# PREFERRED PROJECT REPORT – MP08\_0195

CONCEPT PLAN FOR A MIXED USE DEVELOPMENT

78-90 OLD CANTERBURY ROAD | LEWISHAM

**DATE:** AUGUST 2011

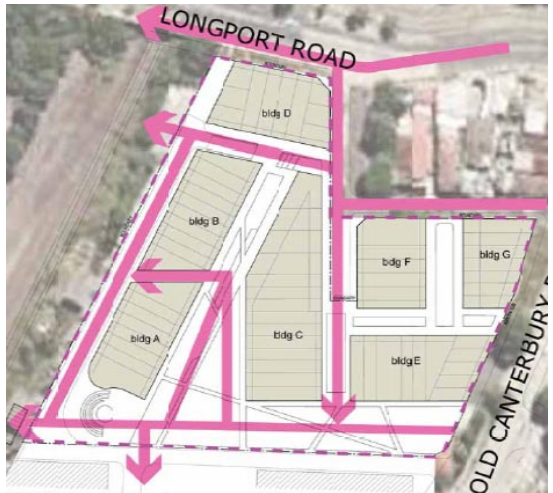
<ul style="list-style-type: none"> <li>• <i>To minimise traffic generation and to encourage use of public transport, the car parking provision (in particular visitor car parking) should be reduced given the site's close proximity to public transport.</i></li> </ul>	<p>Car parking provision in the Concept Plan has been reduced from 669 to between 448 and 492 (dependent on adaptable housing requirements). Visitor parking has reduced from 100 spaces under the EA to 44 spaces in the preferred project while residential parking has decreased from 400 spaces in the EA to 391 spaces under the preferred project despite the slight increase in dwelling yield. There is further opportunity to reduce visitor car parking following commencement of the light rail extension.</p>
<p><b>Open Space, Public Domain and Streetscape</b></p> <ul style="list-style-type: none"> <li>• <i>Further justification and analysis of the amount of open space proposed on site should be provided. The proposed area of open space on site is inconsistent with the McGill Street Precinct Masterplan. Given the significant increase in GFA, dwelling yield and population density above and beyond the Masterplan, a larger area and proportion of the site should also be allocated to public open space. The area available for deep soil planting should also be increased in accordance with SEPP 65 and the Residential Flat Design Code.</i></li> </ul>	<p>Communal open space should be 25-30% of site area or more for large Brownfield sites such as this. The proposal has been amended to reflect these requirements.</p> <p>The provision of open space on the site has been significantly increased by the removal of a section of proposed Building C, the reduced length of Building A and relocation of Hudson Street back to its existing location. In comparison to the McGill Street Precinct Masterplan, the proposed Concept Plan achieves a similar layout for open space adjacent to Hudson Street however a larger area of public open space will be achieved by the concept Plan through extension of the open space in a northerly direction into the site between Buildings A and C. The McGill Street Precinct Masterplan includes public open space area on the site of 3032m<sup>2</sup> whereas the proposed Concept Plan includes a public open space area of 3977m<sup>2</sup>. Building heights have been modified to improve solar penetration into the open space area and into the apartments. The anticipated visual and physical connectivity between Old Canterbury Road and The GreenWay is achieved by the Concept Plan. Total landscaping of the site (including public and communal open space areas) is 5322m<sup>2</sup> whereas Council's masterplan achieves an open space area of 4451m<sup>2</sup>.</p>

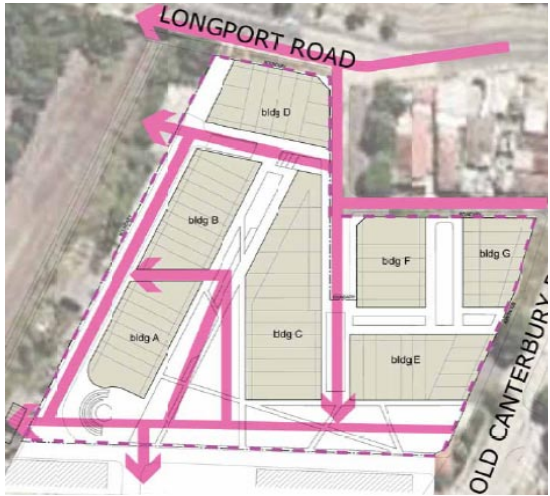
Issue raised by Marrickville Council	Response
<p><i>Movement/connections with surrounds</i>  <i>Providing a new street between the GreenWay and residential buildings. Under the Part 3A (and Part 3A alternate masterplan) the removal of the street on the south of the central park and displacement of the footpath further to the south no longer matches the direct visually legible Lewisham to Summer Hill route proposed under the combined McGill and Allied Mills Masterplans. The exact location of the Light Rail crossing proposed under the Sydney Light Rail Extension Environmental Assessment does not, however, accord with these masterplans, which will need to be addressed in combination with the masterplans and Part 3A assessments.</i></p> <p><i>The Part 3A provides additional connections than Council's masterplan through the triangular shaped open space and through the middle of the buildings adjacent to Old Canterbury Road, however it is unclear if these will allow unrestricted public through movement access, as they appear to be provided primarily to allow access to residential lift lobby entrances. The introduction of alternate pedestrian movement and open space paths disperses and fragments the main pedestrian movement paths (especially the Lewisham to Summer Hill route), creating illegibility and territorial ambiguity for pedestrians and creating potentially unsafe public spaces.</i></p>	<p>Access to and from the GreenWay has been amended and the location of Hudson Street now coincides with Council's masterplan. Access to and from the GreenWay has been discussed elsewhere.</p> <p>Pedestrian access and connections to the Green Boulevard and future light rail have been amended under the preferred project to ensure clear and unobstructed access across the site. A pedestrian footbridge and the café plaza/central green boulevard will provide connections between Lewisham Station / the GreenWay and the site. The preferred concept plans offers increased connectivity between the future light rail and the locality with several connection points to the GreenWay, as shown below.</p>
